Free Drop Impact Analysis ProgramIntroduction

Introduction

In accordance with the requirements of Sec. 71.22 (b) of 10 CFR 71, Subpart B, the materials planned for shipment in the Super Tiger container are described as follows:

Figure 1

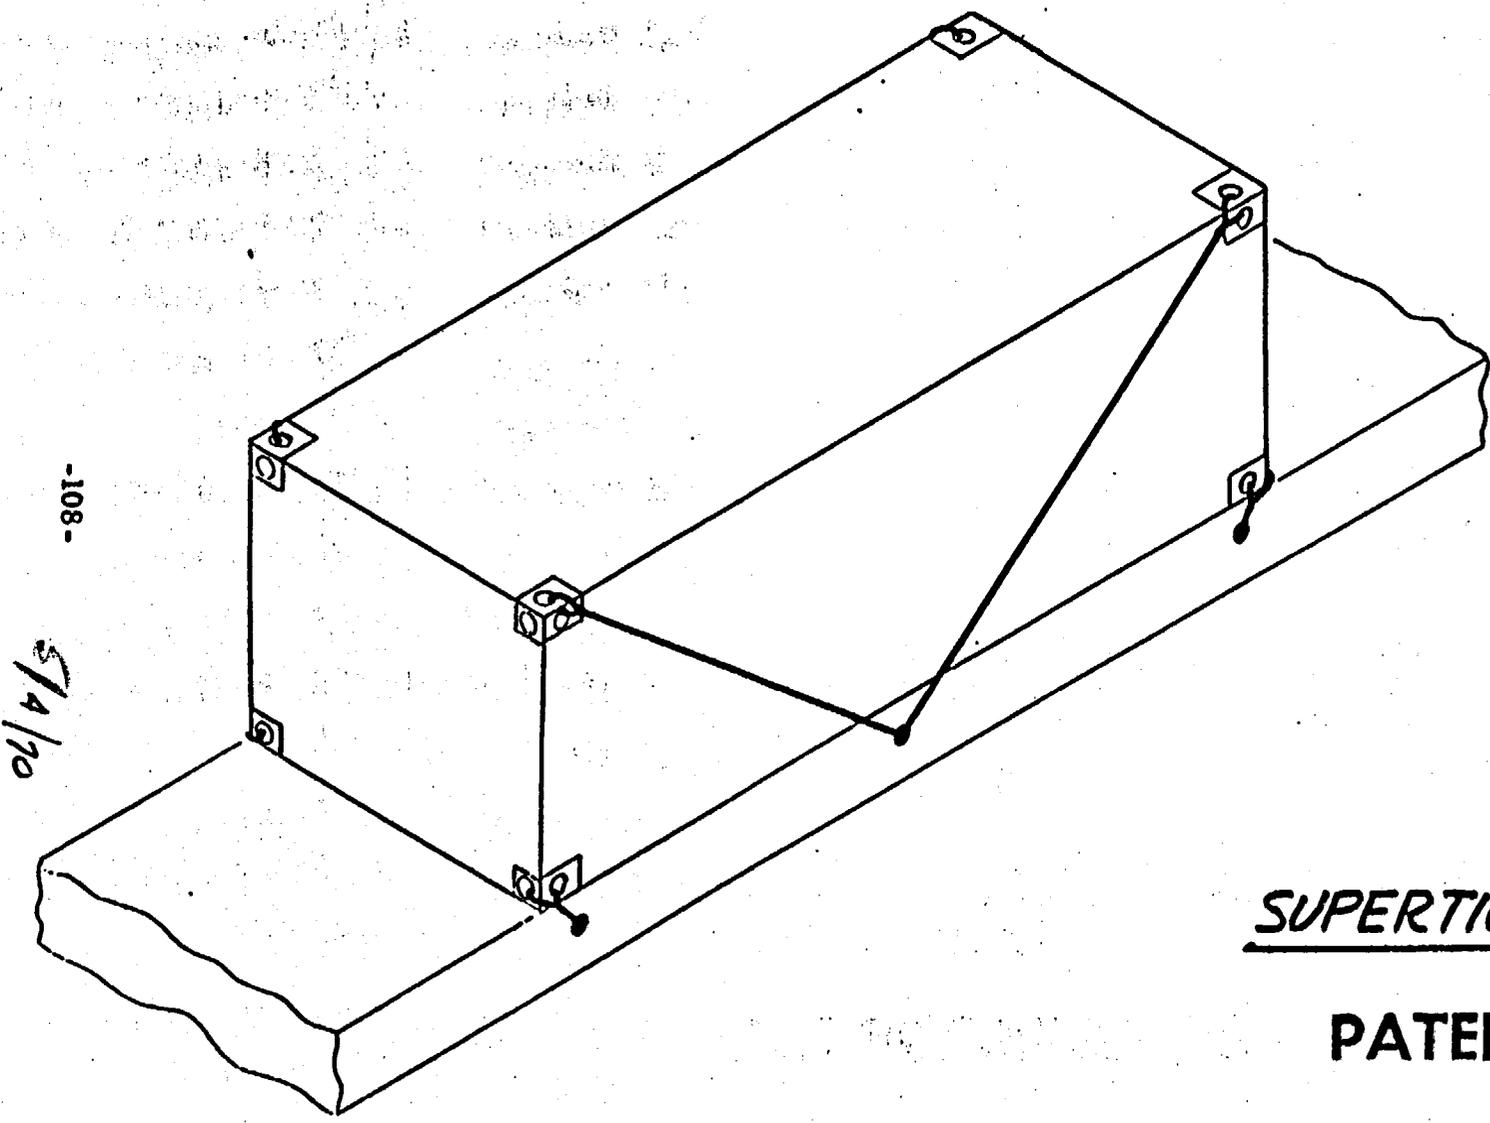
The Super Tiger can be secured using the system of tie downs shown on Figure I.

A detail drawing of the standard ISO and U. S. A. S. I. corner casting is enclosed. Cable loads for the lower castings are reacted by the shear area denoted Area "A." (See Dwg.)

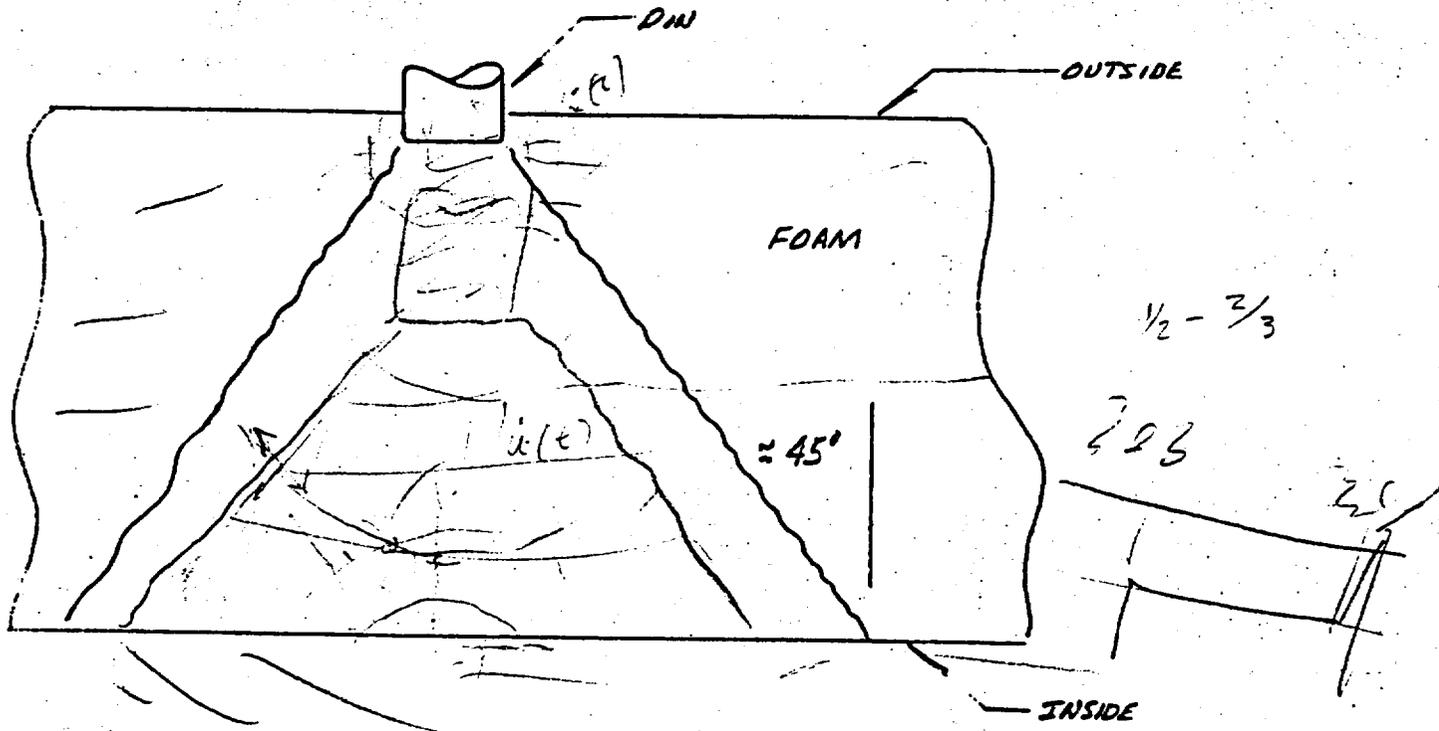
7. The reasoning that led to the conclusion that the 1/8" back-up plates were not required was based on the foams ability (35" thick) to react the puncture loads. Based on the Appendix B analysis, the external skin will puncture. At this point, load is distributed to the foam. Since foam is weaker in tension than compression, it fails on approximately a 45° shear plane.

Conclusion: It is our opinion that the 1/8" back-up sheets are not required on the ends. They are included on all sides as shown in Drawing 121350.

FIGURE 2

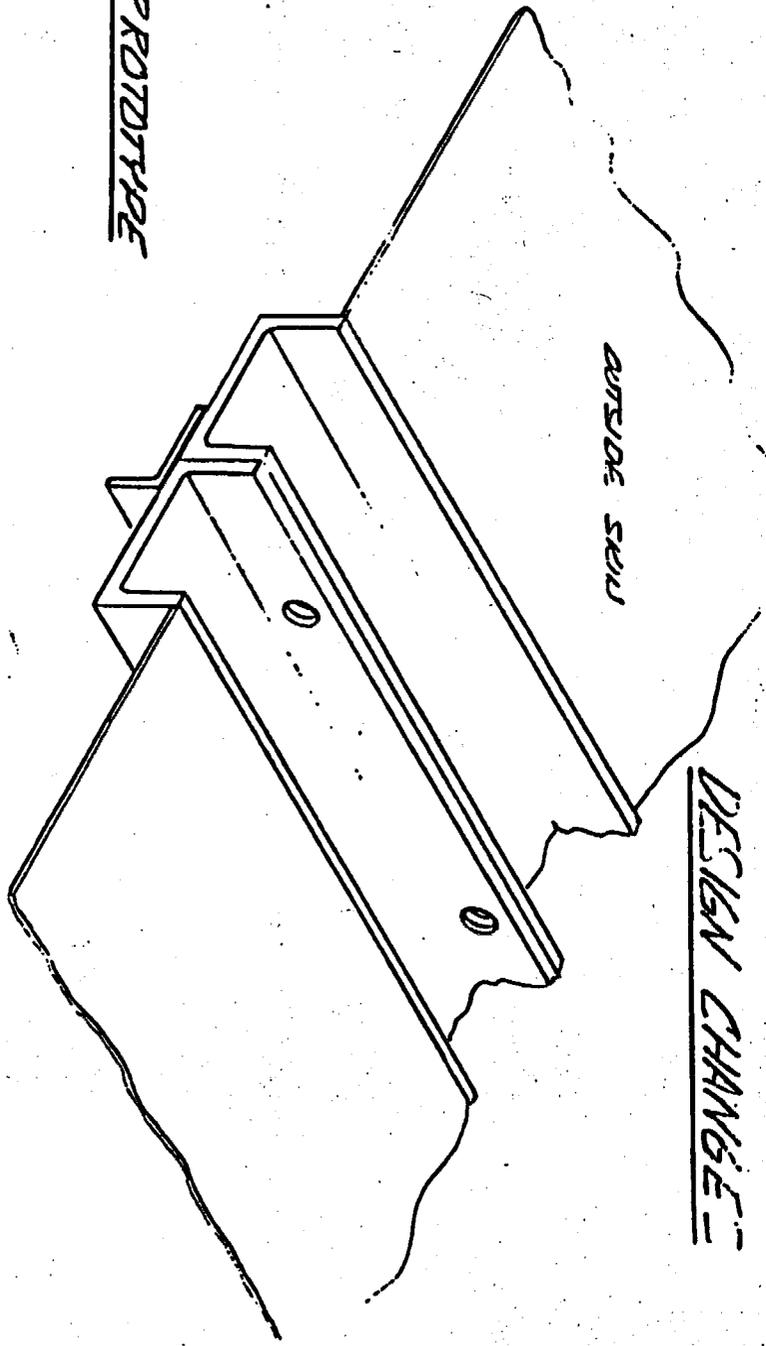
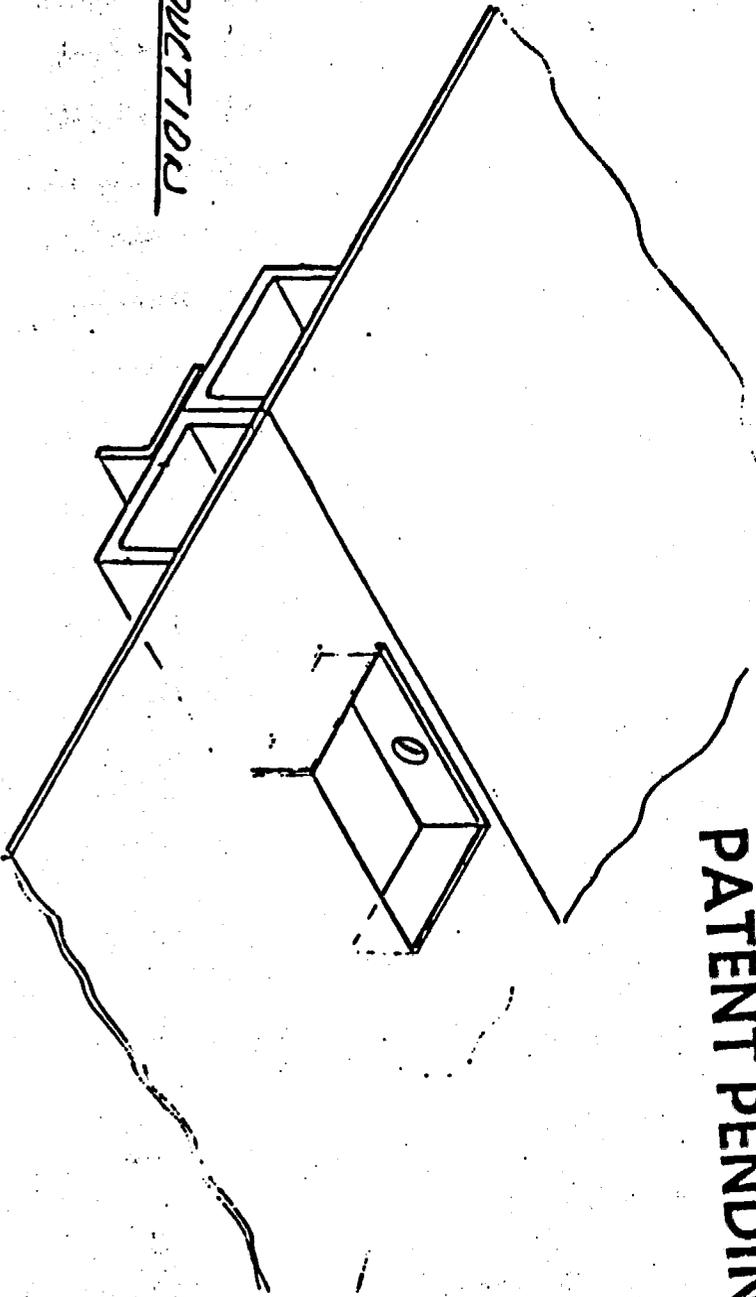
10. Design difference between the prototype and production configuration are shown in the following sketches. The two major structural changes involve the internal and external closure area. These have been reviewed analytically in the answer to question 6.

Conclusion: The seal area configuration of the cover plate was changed from a flat 3/16 steel sheet to a formed 1/4 aluminum plate.

From the comparative EI values and the seal deflection calculations, it is concluded that the production design will provide higher compressive seal pressure than that of the prototype design test. It will provide a pressure tight seal.
